Point Beach Nuclear Plant, Units 1 and 2  
Dockets 50-266 and 50-301  
License Nos. DPR-24 and DPR-27

Response to Request for Additional Information  
Regarding Sections 3.5 and 4.5 of the Point Beach Nuclear Plant  
License Renewal Application  
(TAC Nos. MC2099 and MC 2100)

### RESPONSE TO REQUEST FOR ADDITIONAL INFORMATION POINT BEACH NUCLEAR PLANT, UNITS 1 & 2 LICENSE RENEWAL APPLICATION

**PBNP UNIT 1 - DOME TENDONS (60 YRS)**  
 TOLERANCE BAND OF ACCEPTABLE PRESTRESS FORCE  
 INCLUDING PLOT OF TENDON SURVEILLANCE DATA

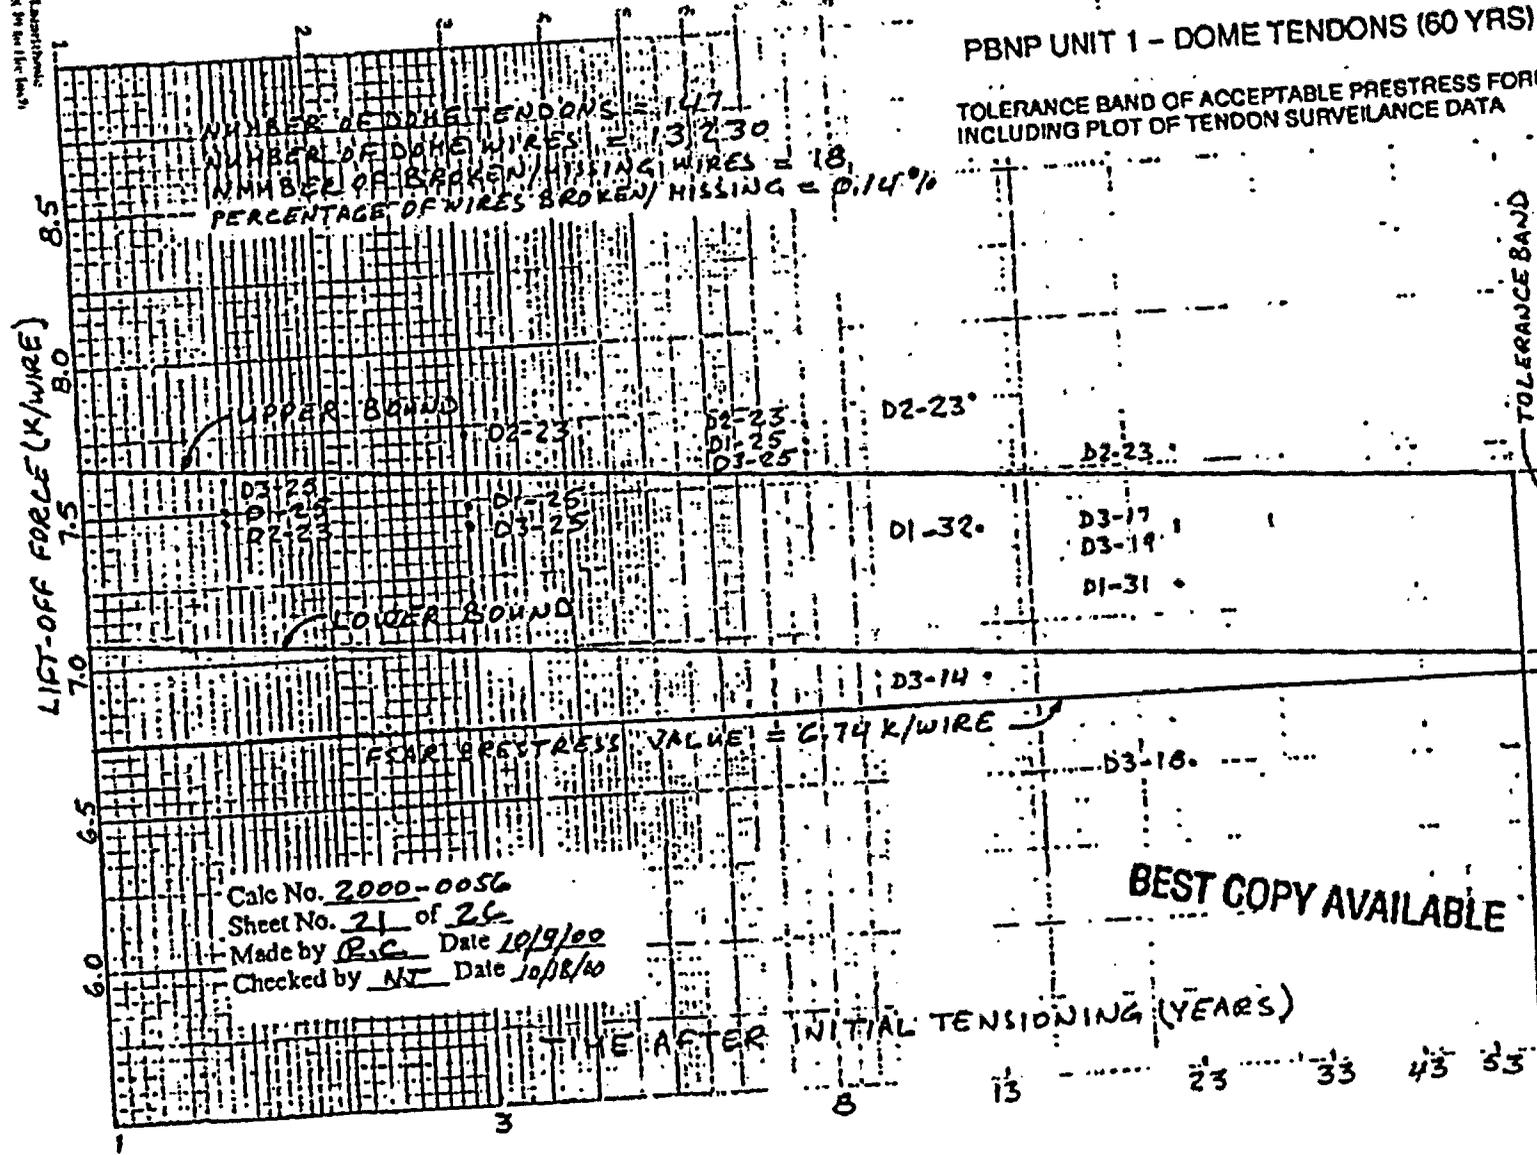
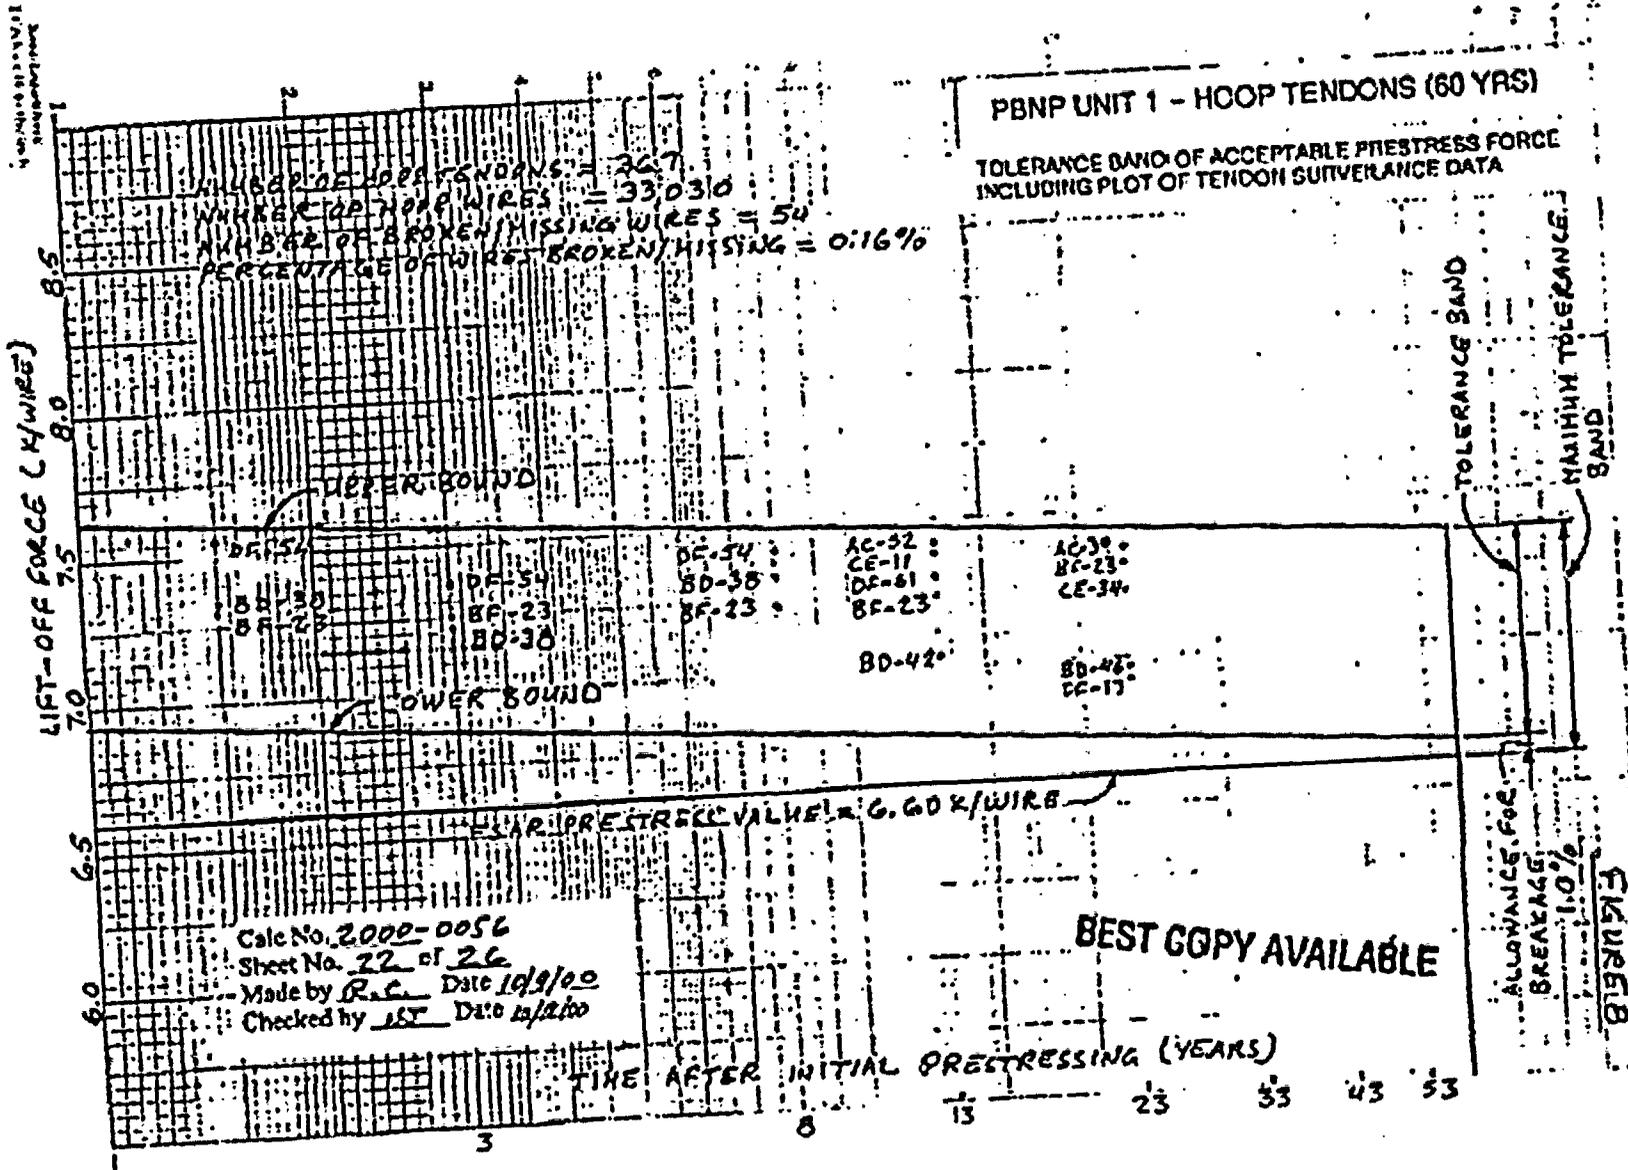
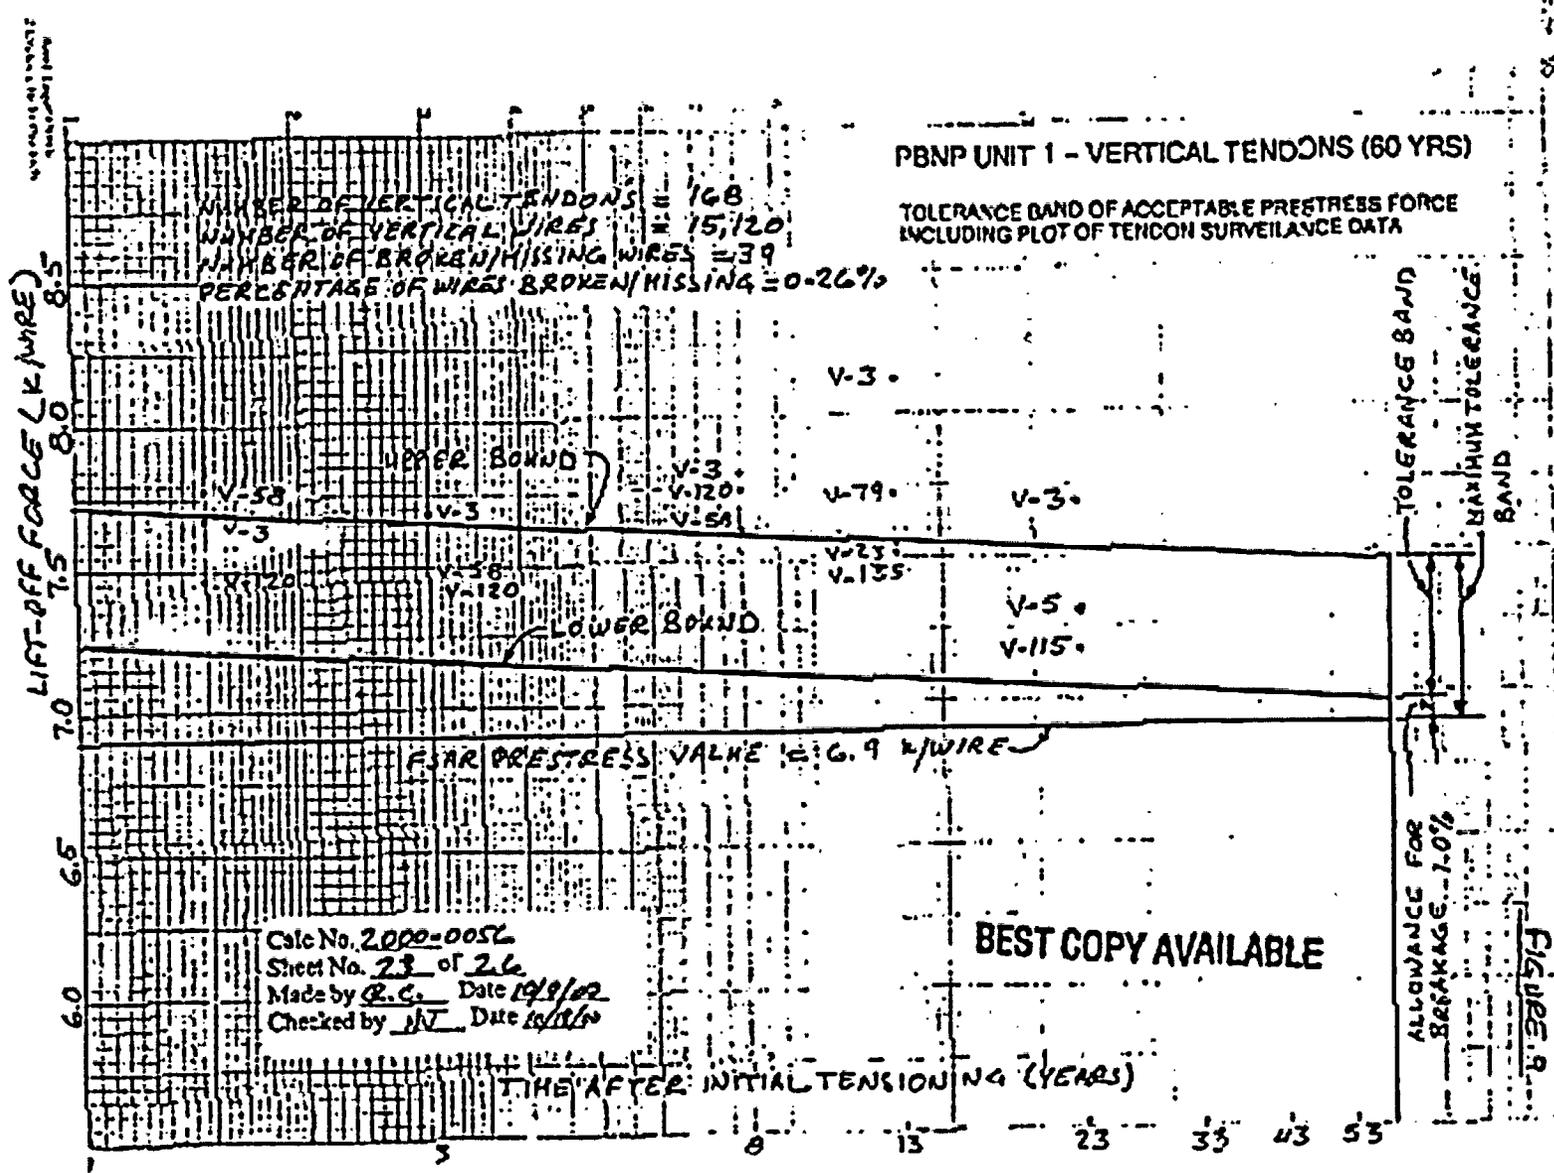
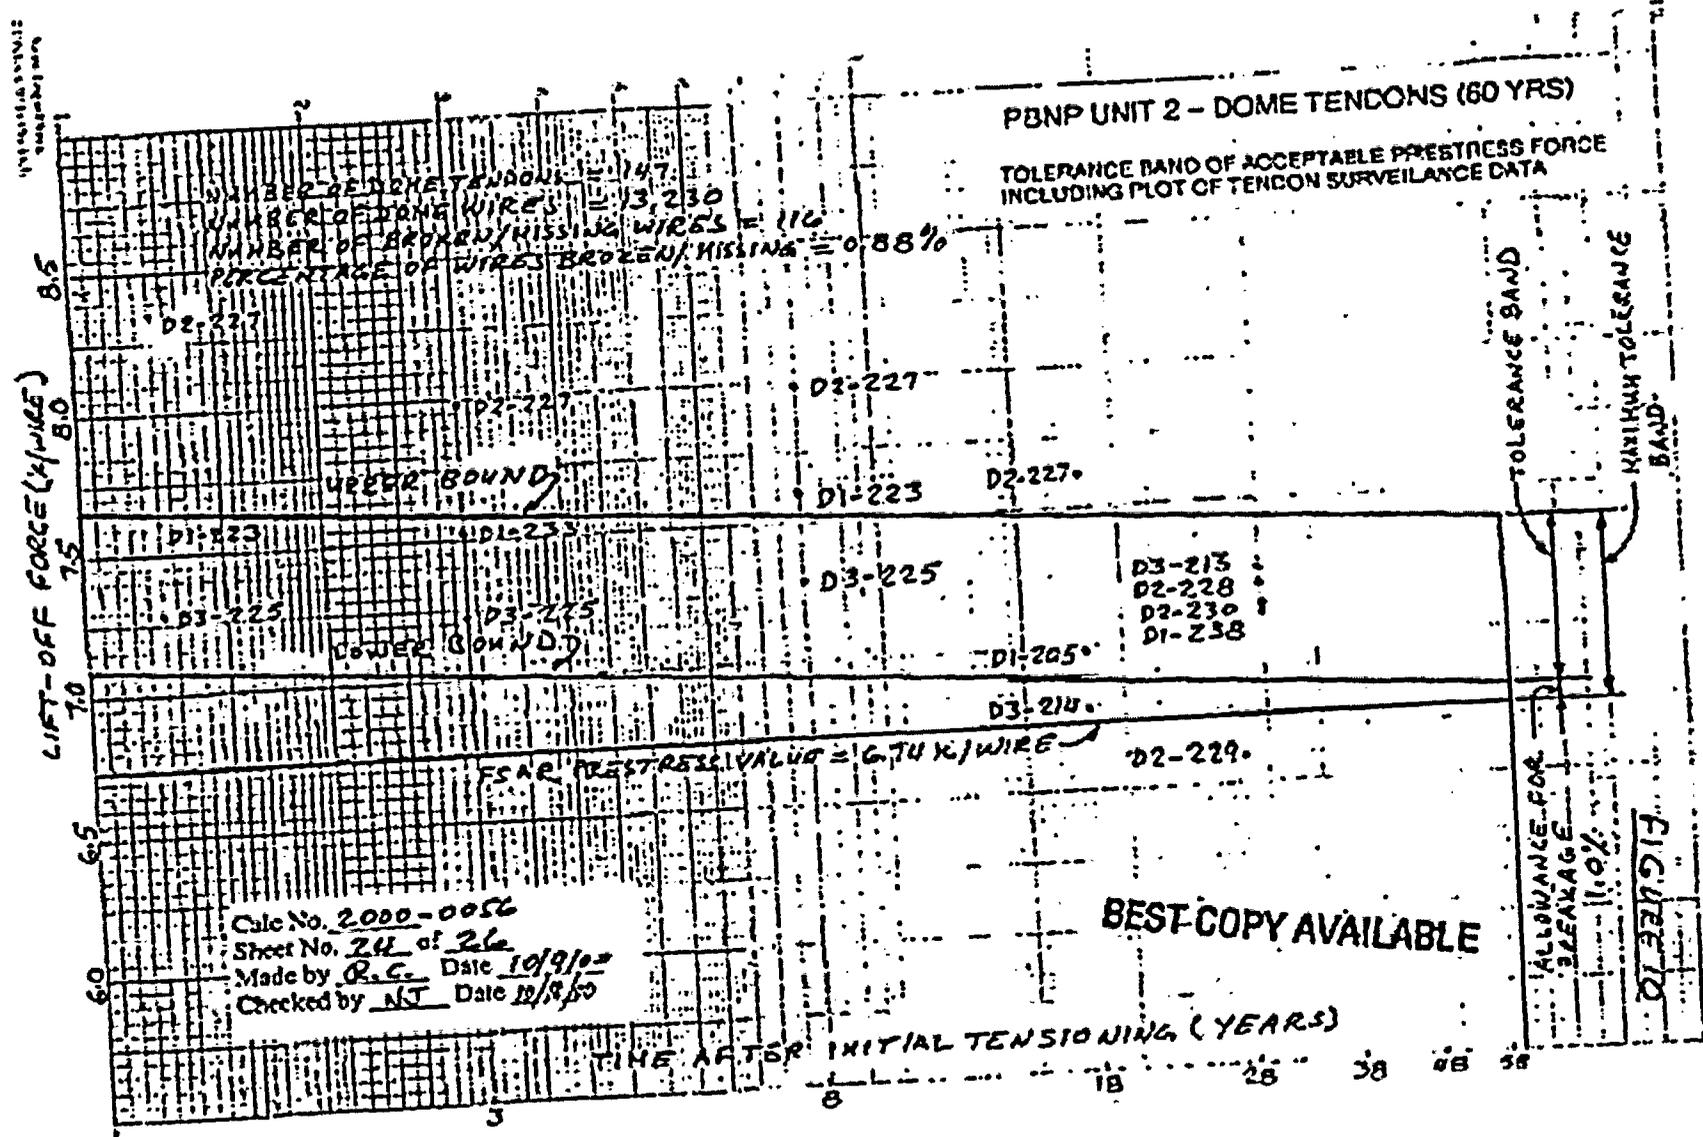
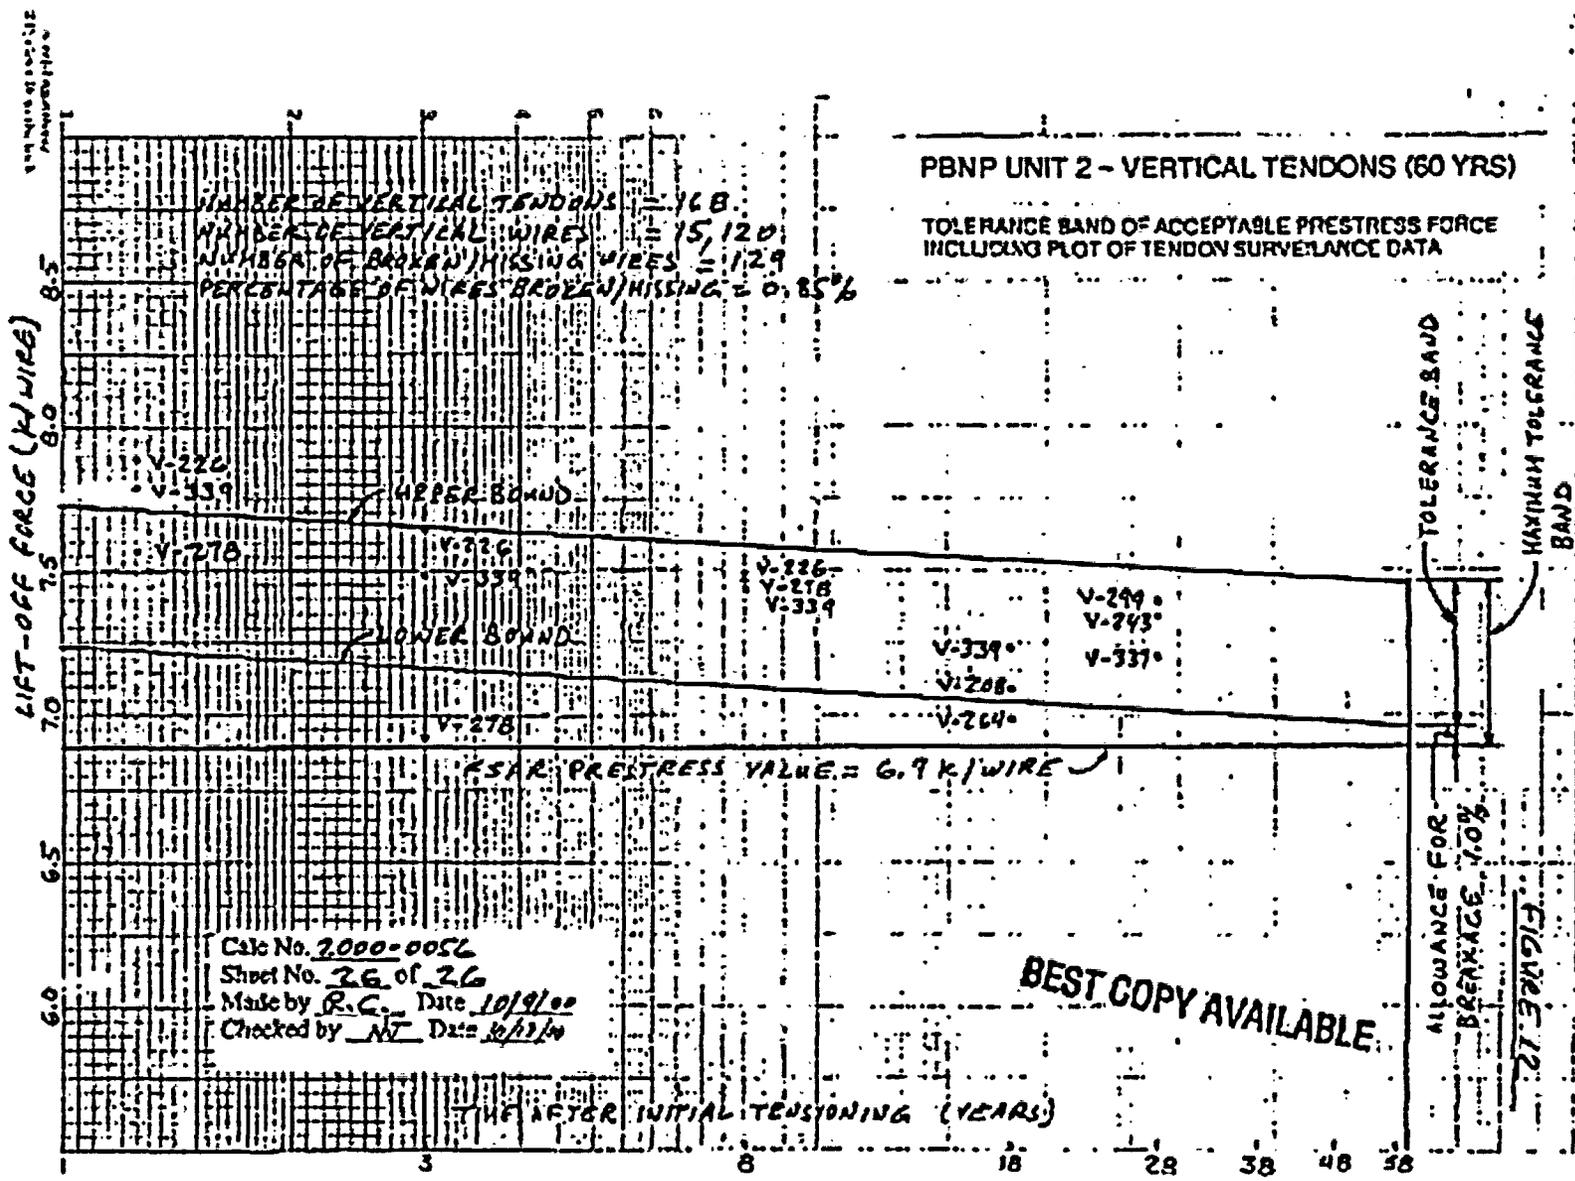
- a. The estimated upper and lower bound lines, and the minimum required prestressing forces for each group of tendons for each containment.
- b. Trend lines of the projected prestressing forces for each group of tendons based on the regression analysis of the measured prestressing forces (see NRC Information Notice 99-10 for more information). Also, show the actual measured prestressing forces that were used to obtain the trend lines.
- c. Plots showing comparisons of prestressing forces projected to 40 years and 60 years with the minimum required prestress (or MRV) for each group of tendons for each containment.

A set of tendon prestressing plots have been developed in accordance with RG 1.35.1, reference Calculation 2000-0056, Tendon Prestress Acceptance Limits, Rev. 0. The plots for 60 years (6 total) include the upper and lower bound lines and the minimum required prestressing force for each group of tendons for each of the containments per RG 1.35.1.
